# CITY OF ALBUQUERQUE

**RE: 1203 Coal Ave SE  
Grading & Drainage Plan  
Engineer's Stamp Date: 2/27/26  
Hydrology File: K15D011  
Case # HYDR-2026-00076**

Based upon the information provided in your submittal received 2/27/2026, the Grading & Drainage Plan **is not approved** for Grading Permit or Building Permit. The following comments need to be addressed for approval of the above referenced project.

ENGINEER'S SEAL	<b>LOT 7-A-1 THRU 7-A-4 BLK 32 TERRACE ADD</b>	DRAWN BY	DEM
	<b>1203 COAL AVENUE SE</b>	DATE	2-24-26
	<b>GRADING AND DRAINAGE PLAN</b>	SHEET #	C1
		JOB #	
DAVID SOULE P.E. #14522	2/27/26

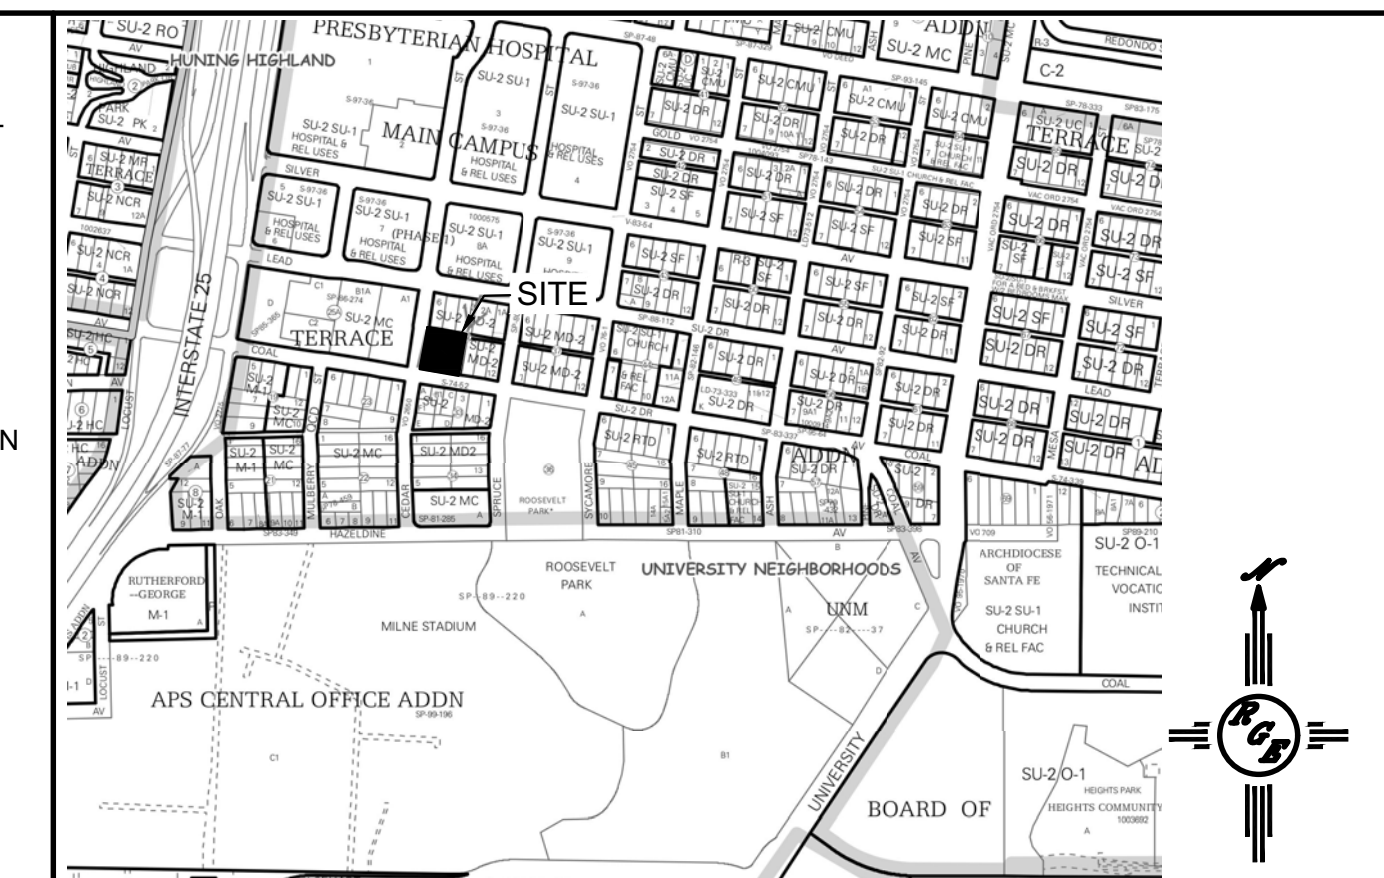
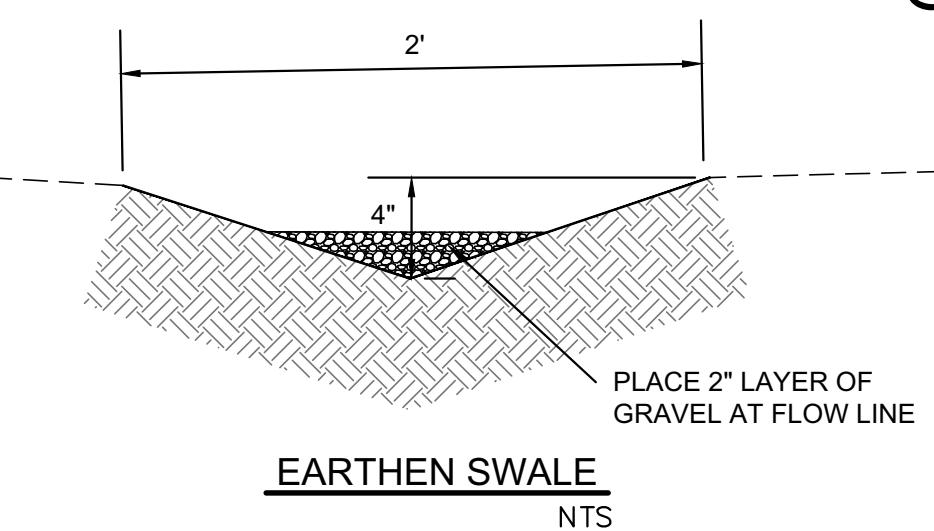
1. An SO-19 Permit will be required and should be included on the request. Please include the [standard SO-19](#) notes on the grading plan.
2. Please provide the FIRM Map and floodplain note with effective date.
3. Provide the existing and proposed grades on both sides of the proposed retaining walls.
